Access Compliance Report

Public Rights-of-Way

(Curb Ramps)

Intersection ID: 21461	Main Street: FOREST_POINT_BV	Cross Street: W_ARROWWOOD_RD	Location: SW
ADA ID: 1C5C24C99C75	Ramp Type: BlendTrans2	Initial Pass/Fail: Pass	Overall Compliance: No
Severity Score: 15.25			
Codes/Mitigation Info/Possible Solution		Field Measurements/Component Compliance

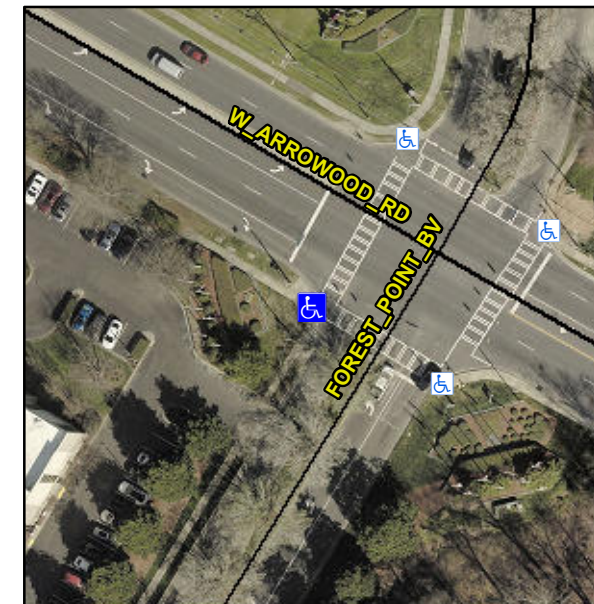
R304.5.3, R304.2.3, R302.7.2

Compliance	Description	Data	Compliance	Description	Data
N/A	Ramp Length (in)	65.0	Yes	BlendTrans Slope (%)	2.8
Yes	Ramp Width (in)	48.0	No	BlendTrans XSlope (%)	3.8
N/A	Flare Type LT	Sloped	N/A	Flare Type RT	Sloped
No	Flare Slope LT (%)	N/A	No	Flare Slope RT (%)	N/A
N/A	Flare Traversable LT?	Yes	N/A	Flare Traversable RT?	Yes
N/A	Landing Length (in)	N/A	Yes	DWS Provided?	Yes
N/A	Landing Width (in)	N/A	Yes	DWS Contrast?	Yes
N/A	Landing Slope (%)	N/A	Yes	DWS Length (in)	24.5
N/A	Landing X Slope (%)	N/A	Yes	DWS Full Width?	Yes
N/A	Landing Curb? (Y/N)	No	Yes	DWS Offset (in)	0.0
N/A	Shared Landing?	No			
Yes	Gutter Ponding?	No	Yes	Gutter Slope (%)	3.4
No	Gutter Lip Ht (in)	1.0	Yes	Gutter X Slope (%)	0.2
N/A	Painted X Walk1?	Yes	N/A	Painted X Walk2?	Yes
	X Walk 1 Direction	To SE		X Walk 2 Direction	To NE
	X Walk 1 Width (in)	102.0		X Walk 2 Width (in)	106.5
	X Walk 1 Slope (%)	4.7		X Walk 2 Slope (%)	3.5
	X Walk 1 X Slope (%)	3.5		X Walk 2 X Slope (%)	4.6

Yes	Ramp inside XWalk1?	Yes	Yes	Ramp inside XWalk2?	Yes
	Road Slope (%)	0.5		Clear Space?	Yes
	Road X Slope (%)	4.4	Yes	Clear Space to XWalk (in)	120.0
Yes	Any Obstructions?	No	Yes	Storm Grate/Utility Hazard?	No
	Obstruction Type			Storm Grate/Utility Type	
		N/A			N/A
			Yes	Surface Condition? (G/P)	Good
			N/A	Curb Slope (%)	3.4

Remove & Replace Curb Ramp With Two New Directional Ramps or Equivalent. Grind Gutter Lip.
